**Re: SSD-17424905 – 20 Avon Road, Pymble**

We refer to Development Application No. SSD-17424905 which proposes the following works:

We write to formally submit an objection to the proposed development on the following grounds:

Figure 3: Extract of Acoustic Report - Proposed acoustic walls

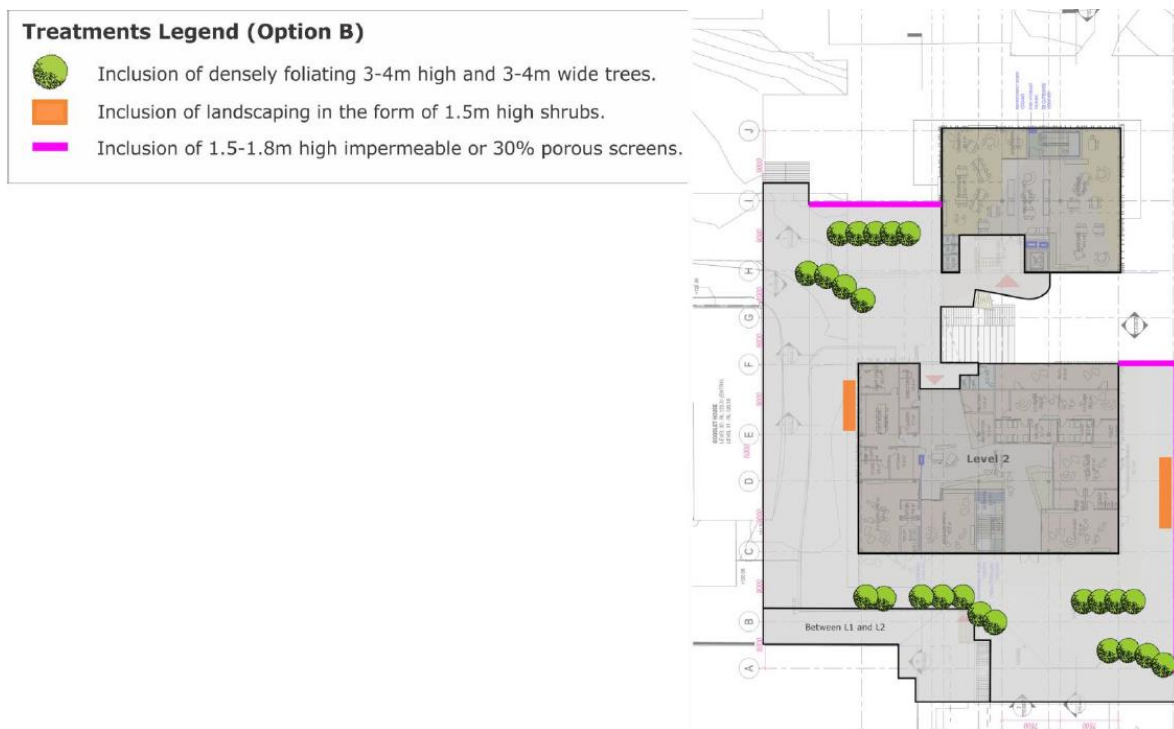
The documentation submitted with the application contains discrepancies between the noise impact assessment (NIA) and architectural plans with regard to an acoustic wall associated with the ELC.

The NIA recommends a solid barrier to the perimeter of the level 2 external play area of the ELC, such as glass or the like with a height of no less than 1.5m above the floor of level 2. However, the architectural plans indicate a metal palisade fence to the perimeter of the level 2 outdoor play area. Further, the wind study recommends a 1.5-1.8m high impermeable or 30% porous screen along the north-eastern and south-eastern boundaries of the level 2 outdoor play area – see extract from NIA below:
